工程指示 / 要求簡箋(E.I.)

工程指示編號：EI / 8938 / 25 修改版次：B

工程名稱：將軍澳日出康城

工程項目：幕牆 第 1 次 補玻璃 25 件 (小業主單)

GLD-03
AIBC
GL01-19
AIBC

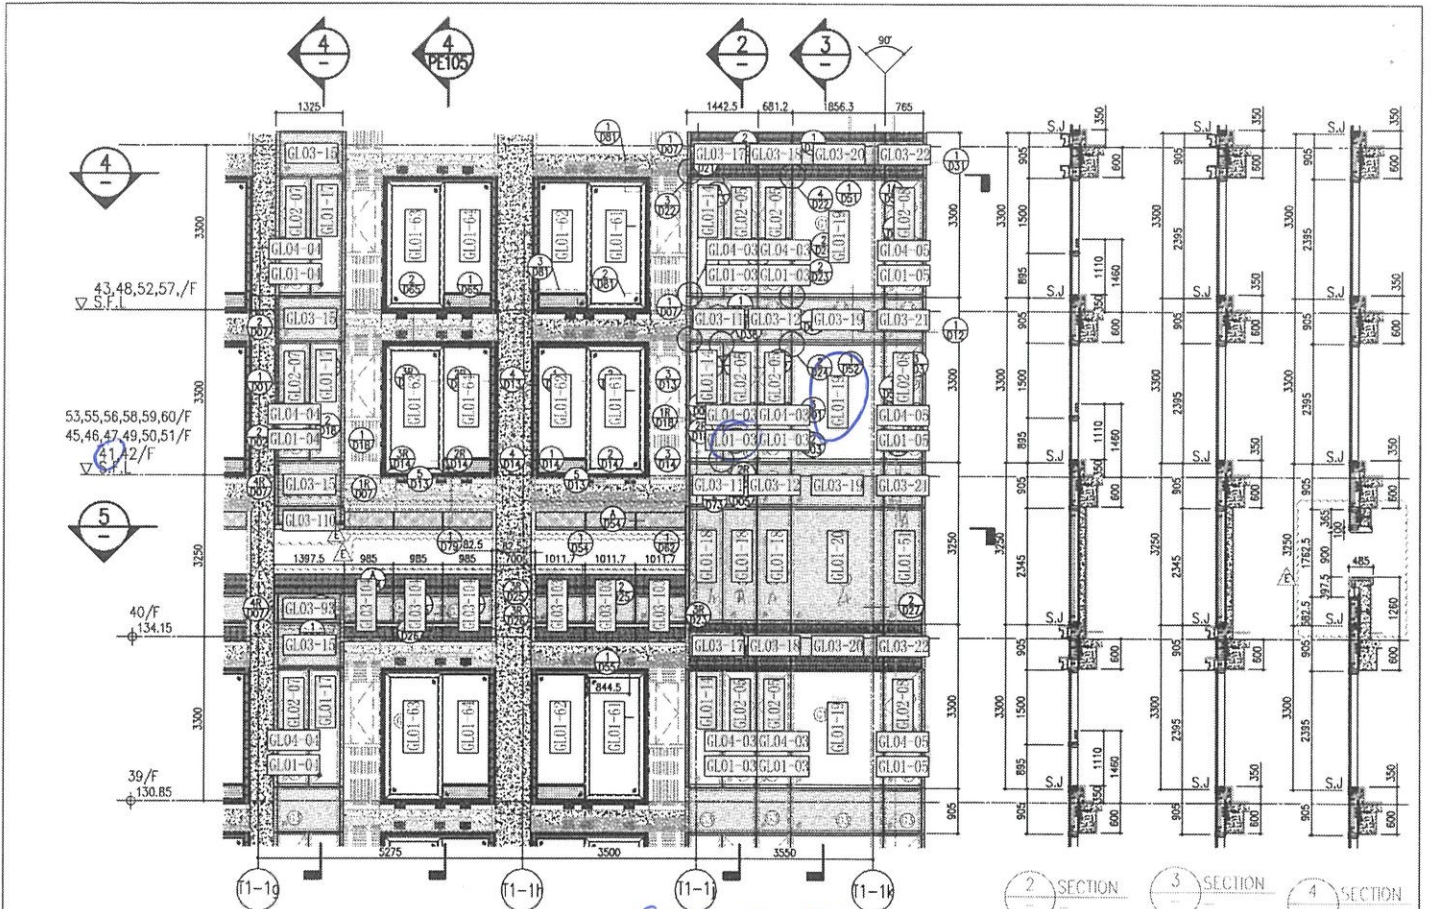
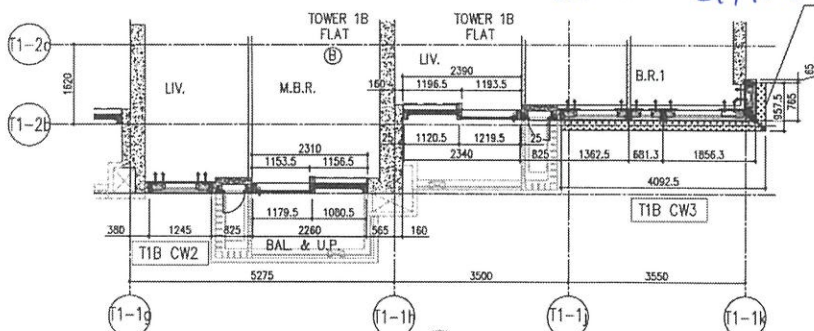
B 版次 增加至 25 件A 版次 增加至 17 件序號 70 修改玻璃編號, 序號 69 修改位置, 序號 76 不合格氣泡由於地盤需要更換玻璃，請按玻璃 BM 生產玻璃，共 17 件 送地盤。請安排熱浸

1. 不要印上熱浸標籤。只給”可移除”的標籤。
2. 依原 EI 4867, EI 4943, EI 4942 尺寸補，
3. *****分座包箱， 玻璃標籤請註明樓層、單位。***** 請留意。
4. 第一次補 25 件本次
5. 地盆：更換幕牆玻璃，需用吊船。
6. 按芳姐 資料
